REPORT TO PLANNING COMMISSION

Hearing Date: May 13, 2013
File Number: 2012-7986

SUBJECT: **Jasbir Tatla**: Application for a project located at **726 San Miguel Avenue** in an R-0 Zoning District (APN: 205-14-030):

Motion **2012-7986 –** Design Review to allow a new two-story single-family home resulting in 2,804 square feet and 53.5% Floor Area Ratio (FAR).

① BLOCK DIAGRAM FIRST FLOOR

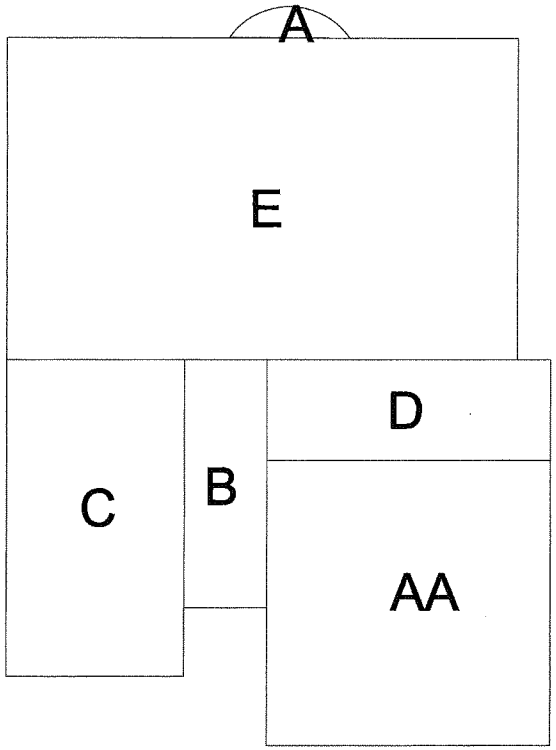
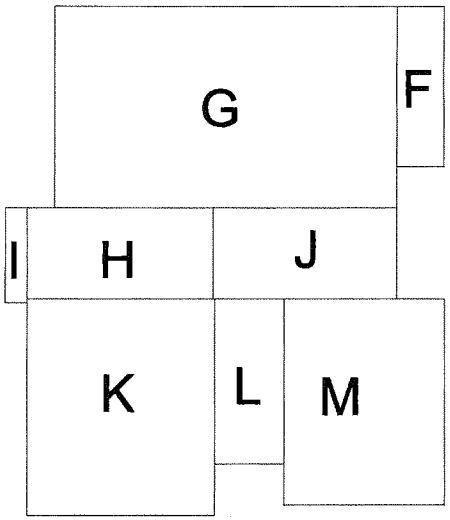
The neighborhood for this site is composed entirely of single-story homes. The original proposal included a second floor area of 1,009 square feet, or approximately 51.8% of the 1,949 square-foot first floor area. The revised project includes a smaller second floor area of 953 square feet, which is approximately 51.5% of the 1,851 square-foot first floor area. While the second floor area was reduced slightly, the first floor area was also reduced and the overall proportion of first to second floor area remains about the same. As a result, staff finds the project is still not in compliance with the Design Techniques related to second floor area. Although Design Techniques for reducing second-story bulk have been included in the project design, the bulk of the resulting second-story would still be out of character with the surrounding single-story neighborhood.

applicant has reduced the overall size of the home, the proposed FAR remains higher than typical FARs the neighborhood. In addition, the proposed design continues to have significant second-story bulk, with a second floor area equal to 51.5% of the first floor area. Floor plan changes including relocating bedrooms to the ground floor could be used to substantially reduce second floor area. However, the applicant has indicated he is unwilling to relocate any of the four proposed bedrooms.

b) Reduce second floor area to no more than 35% of the first floor area. The modified design shall be generally consistent in style, character, and detail with the current project plans.

② SUN STUDY

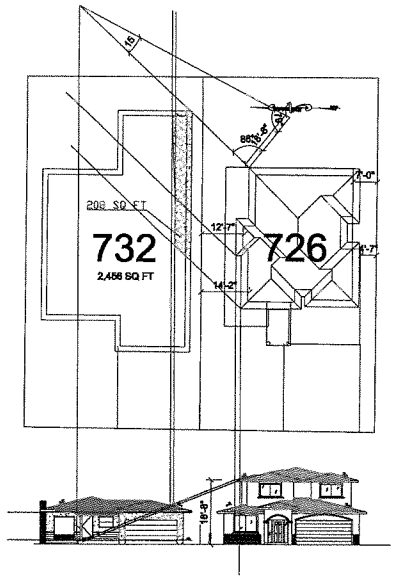
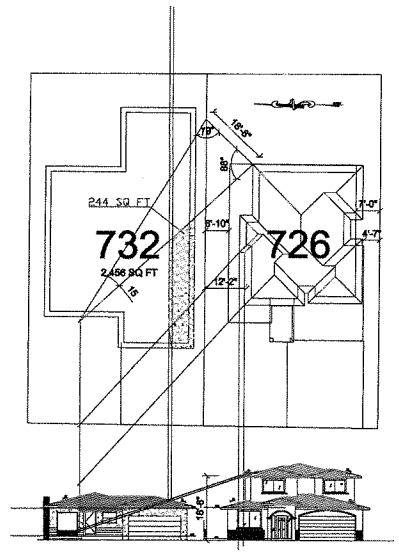
SMC 19.56.020 states that no permit may be issued for any construction which would interfere with solar access by shading more than 10% of the roof of any structure on a nearby property. The original project plans considered on April 22, 2013, were not in compliance with the limitation on shading (see Attachment G – Project Plans for Original Design). The revised plans include a smaller second story element which reduces shading in compliance with solar access requirements (see Attachment F – Project Plans for Revised Design).
